Product Change Notice (PCN)

PCN Number: PCN-0455011R-01

Product(s) Affected: *SJ-3523-SMT-TR & SJ-3524-SMT-TR*

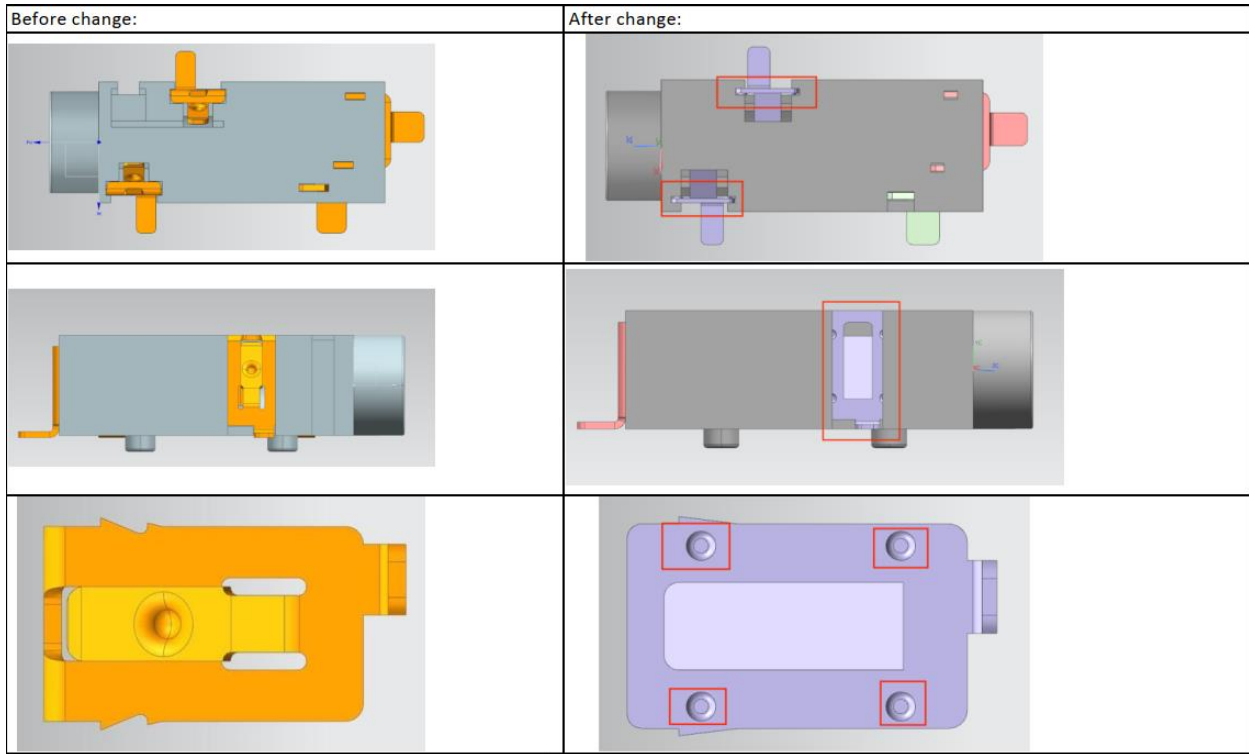
Description of Change:

- 1) Removal of additional slots in the base. Plastic structural change.
- 2) Hardware/Shielding adjustment.
- 3) Terminal 4 material change to Brass.

No Change to PCB Footprint

See image below for reference and check Same Sky website for updated drawing on or after **12/10/2024**. Cosmetic differences may be visible due to new molds and not affect the form fit and function of the product.
